SAWMILL CREEK ADDITION

RE: S/D 99-87 -- Final Plat of SAWMILL CREEK ADDITION

RE: S/D 99-87 -- Final Plat of SAWMILL CREEK ADDITION

CASE NUMBER: S/D 99-87 -- SAWMILL CREEK ADDITION

SAWMILL CREEK ADDITION

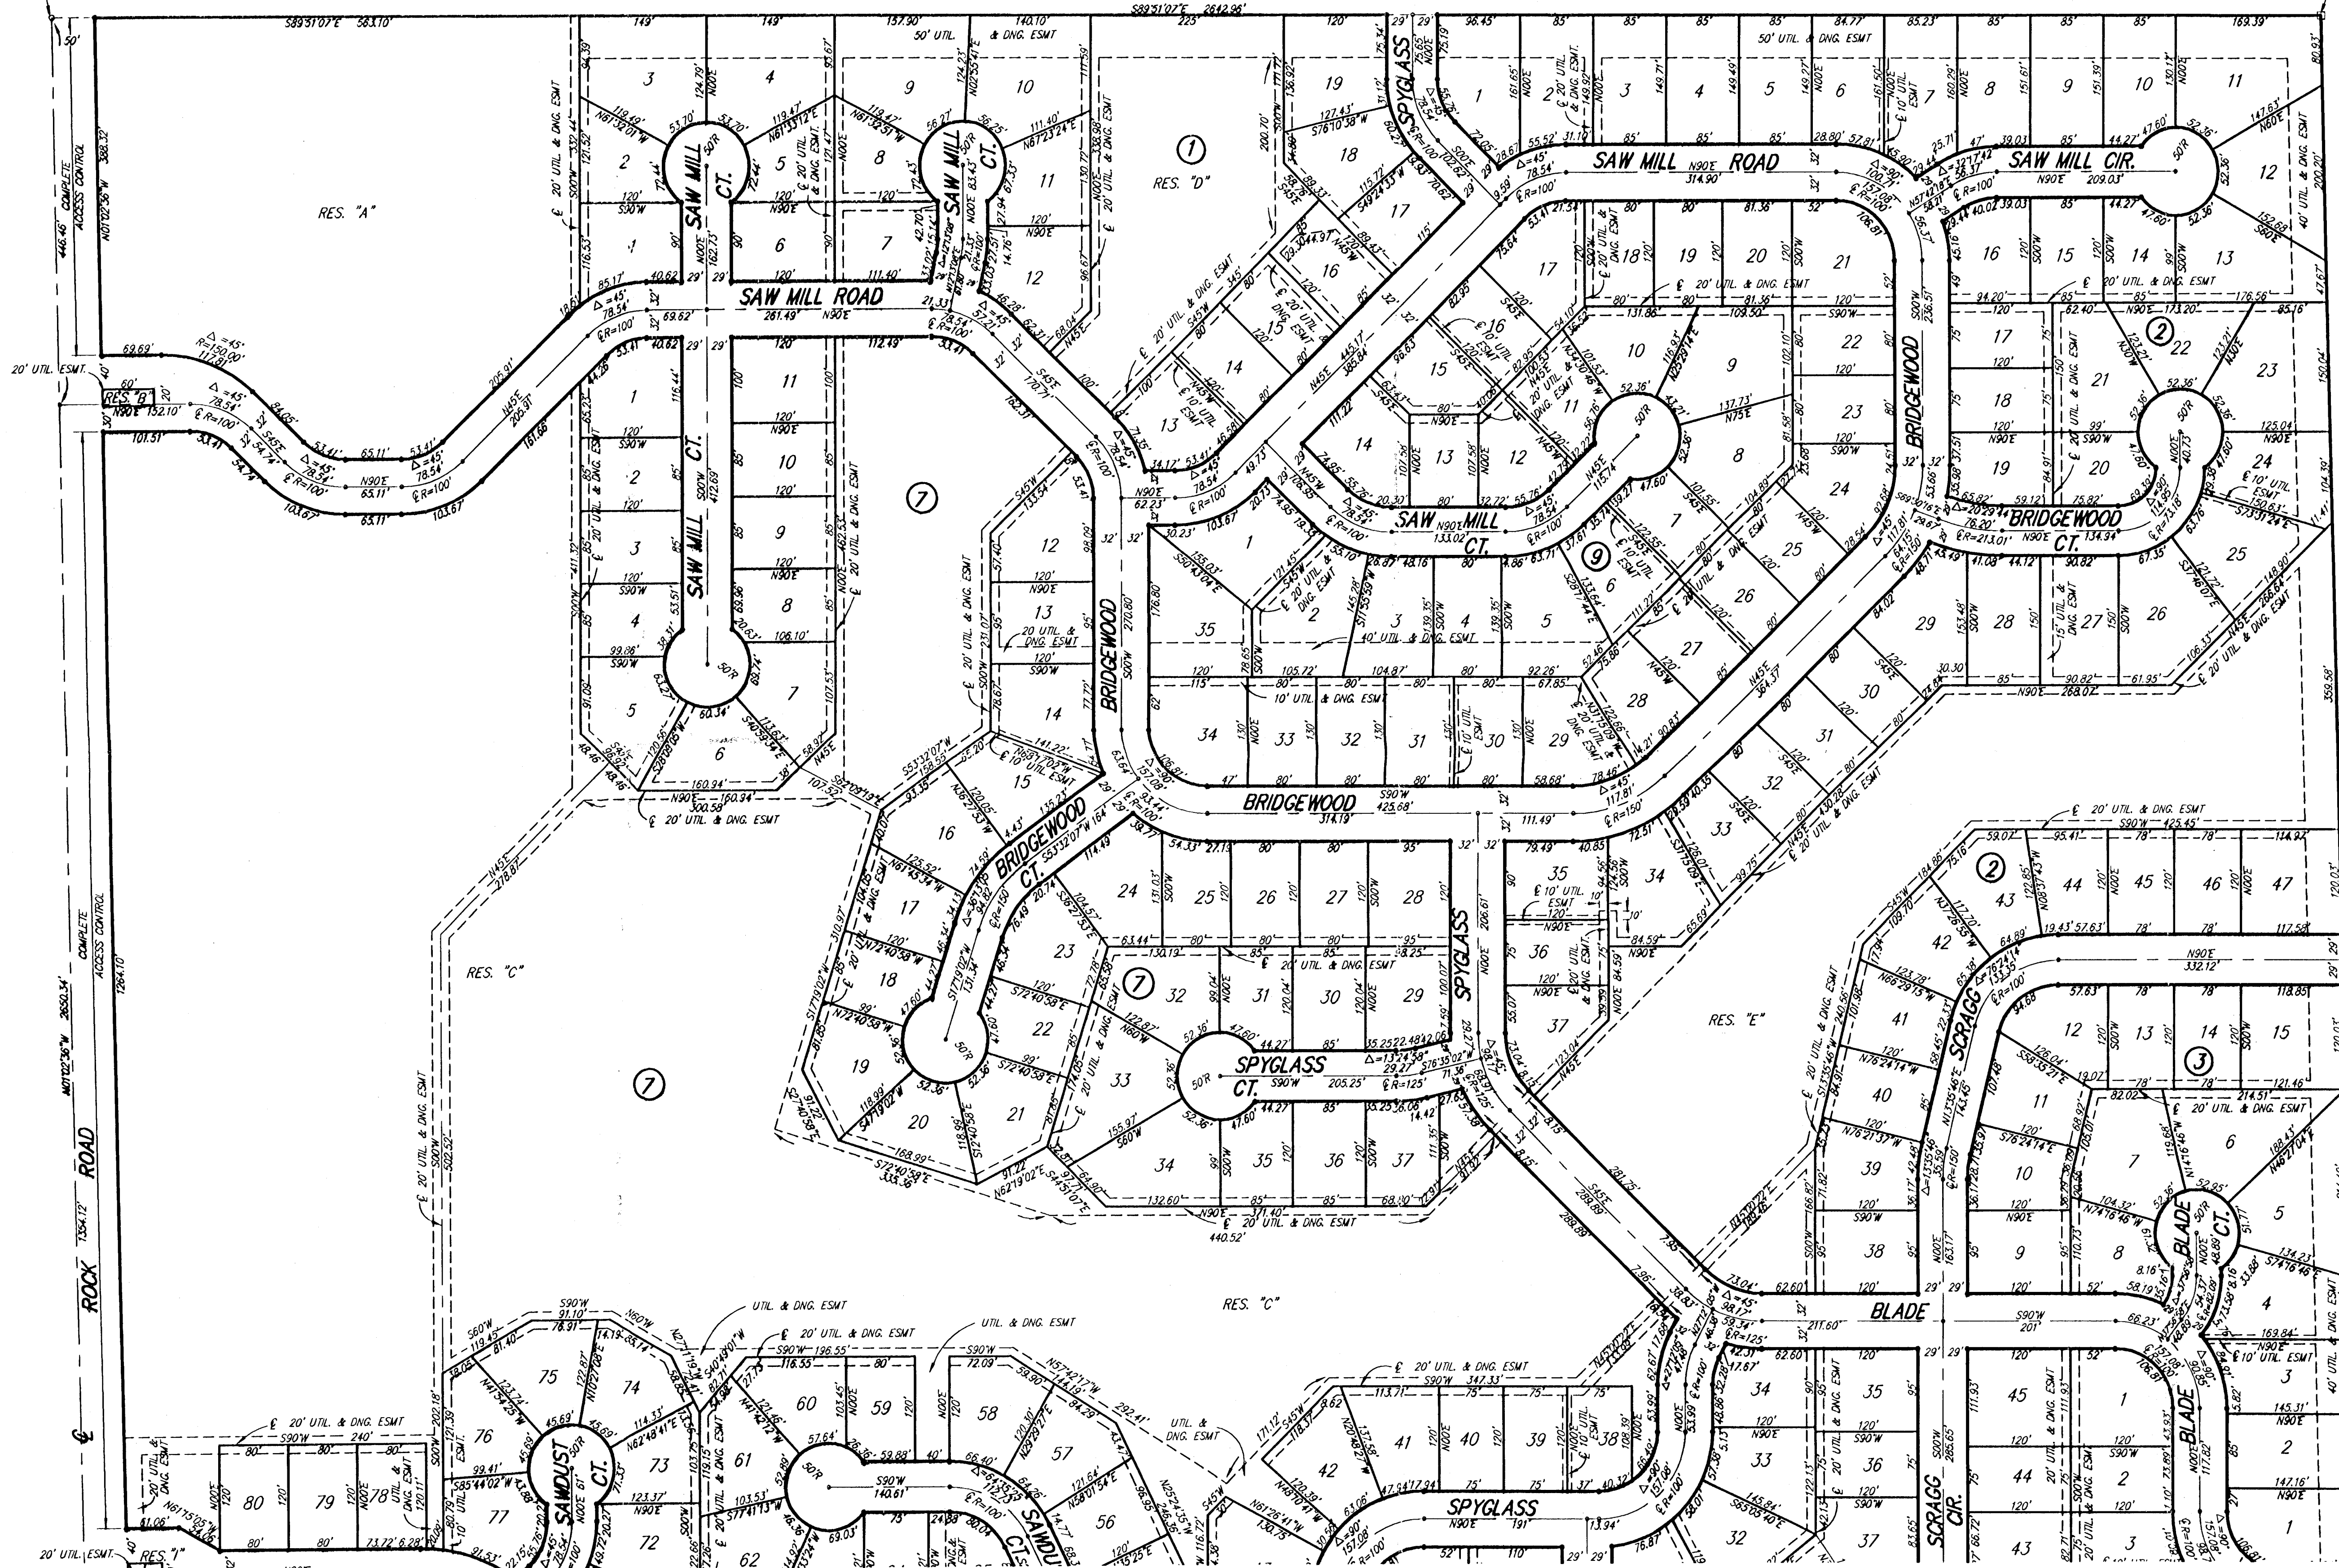
- O. The benchmark elevations should be checked.
- P. Reserve B needs to be located.
- Q. Road rights-of-way near Reserve B, Reserve F, Reserve H, and Reserve I need to be dimensioned.

- R. Curve data at the west end of Saw Mill Road on the north side needs to be labeled.
- S. The utility and drainage easement labeled on Lot 9, Block 1, needs to be changed to 40 feet.

- T. The following items need to be labeled: easements on Lot 13, Block 7; Lot 27, Block 2; Lots 29-34, Block 7; road right-of-way on the northwest corner of the plat; curve data near Reserve H on the east and west sides of the road; property line information on Reserve G; point of intersection (P.I.) on Lot 14, Block 4 bearing southwesterly; P.I. on the northwest line of Lot 1, Block 8 bearing southwesterly; and widths of Access Control along Lot 1, Block 8 and Lot 52, Block 6.

- U. The following items need to be located: easement in Reserve C near Lot 16, Block 7; easement on Lot 38, Block 5; easement in Reserve C near Lot 38, Block 7; easement in Reserve E near Lots 38 and 39, Block 2;

- V. Reserve H needs to be dimensioned.
- W. The applicant shall submit a covenant which provides for four (4) off-street parking spaces per dwelling unit on each lot which abuts a 58-foot street. The covenant shall inventory the affected lots by lot and block number and shall state that the covenant runs with the land and is binding on future owners and assigns.

SAWMILL CREEK ADDITION

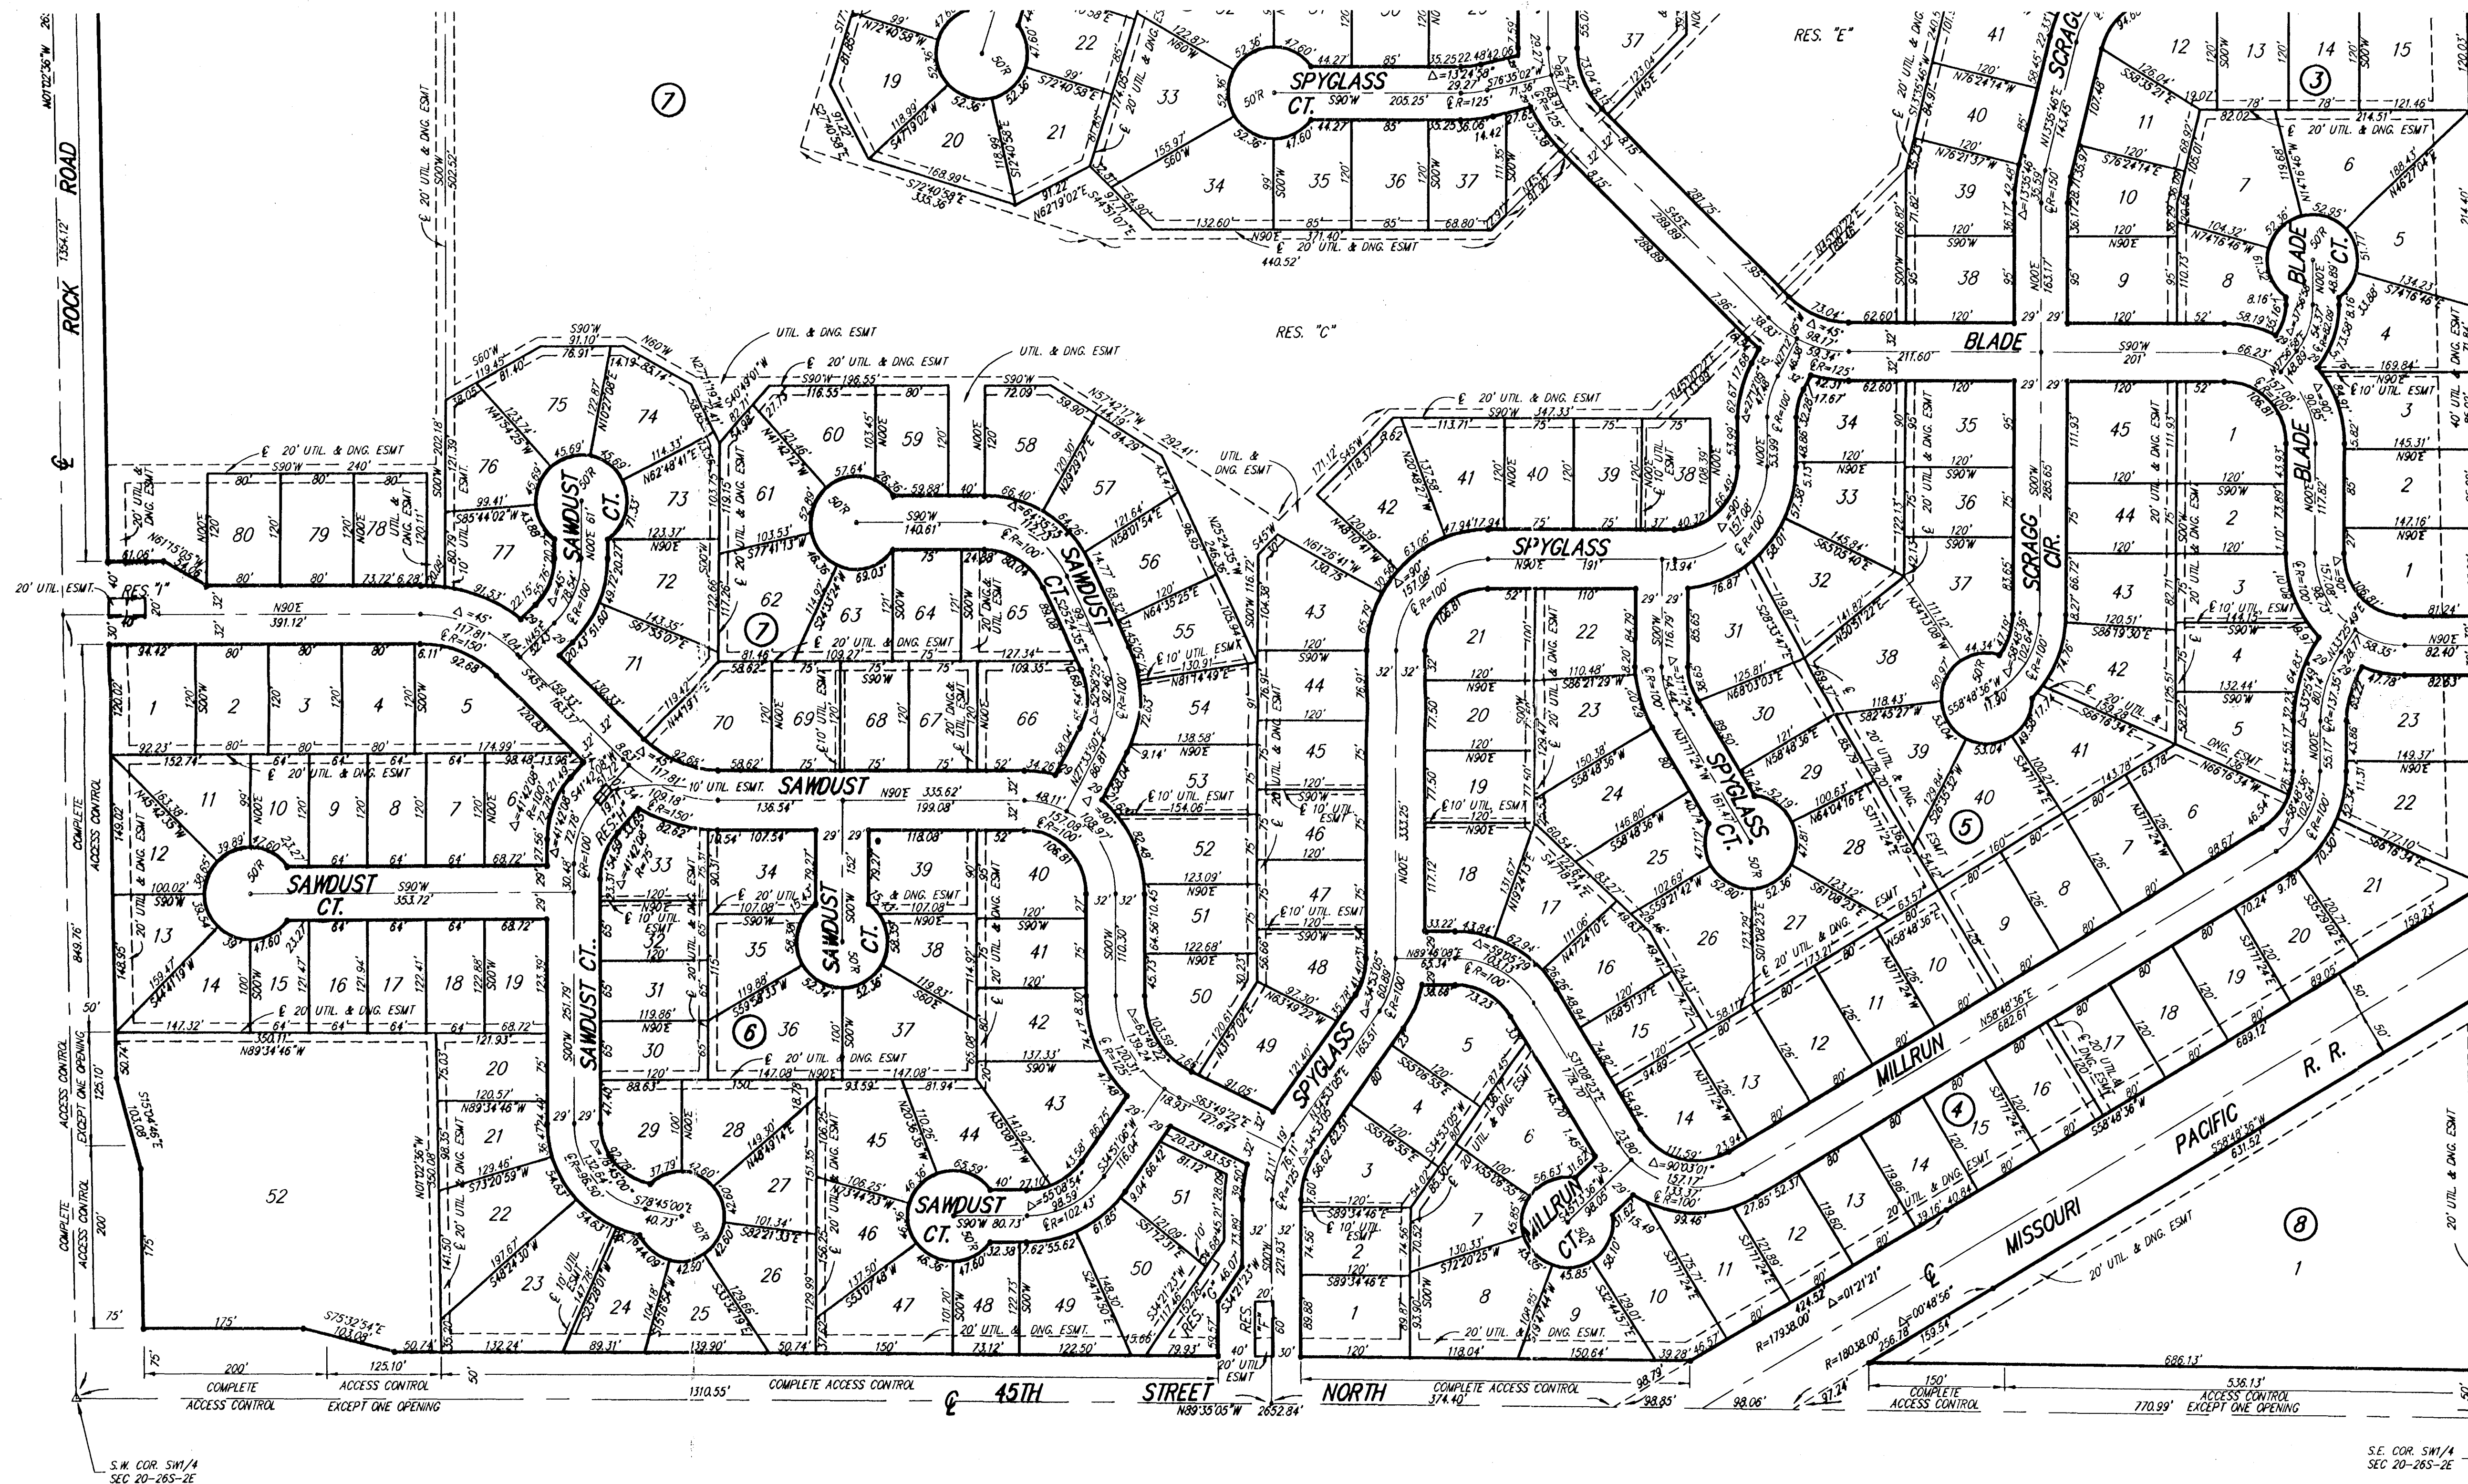
- O. The benchmark elevations should be checked.

- P. Reserve B needs to be located.

- Q. Road rights-of-way near Reserve B, Reserve F, Reserve H, and Reserve I need to be dimensioned.

- R. Curve data at the west end of Saw Mill Road on the north side needs to be labeled.

- S. The utility and drainage easement labeled on Lot 9, Block 1, needs to be changed to 40 feet.

- T. The following items need to be labeled: easements on Lot 13, Block 7; Lot 27, Block 2; Lots 29-34, Block 7; road right-of-way on the northwest corner of the plat; curve data near

Reserve H on the east and west sides of the road; property line information on Reserve G; point of intersection (P.I.) on Lot 14, Block 4 bearing southwesterly; P.I. on the northwest line of Lot 1, Block 8 bearing southwesterly; and widths of Access Control along Lot 1, Block 8 and Lot 52, Block 6.

- U. The following items need to be located: easement in Reserve C near Lot 16, Block 7; easement on Lot 38, Block 5; easement in Reserve C near Lot 38, Block 7; easement in Reserve E near Lots 38 and 39, Block 2;

- V. Reserve H needs to be dimensioned.
- W. The applicant shall submit a covenant which provides for four (4) off-street parking spaces per dwelling unit on each lot which abuts a 58-foot street. The covenant shall inventory the affected lots by lot and block number and shall state that the covenant runs with the land and is binding on future owners and assigns.
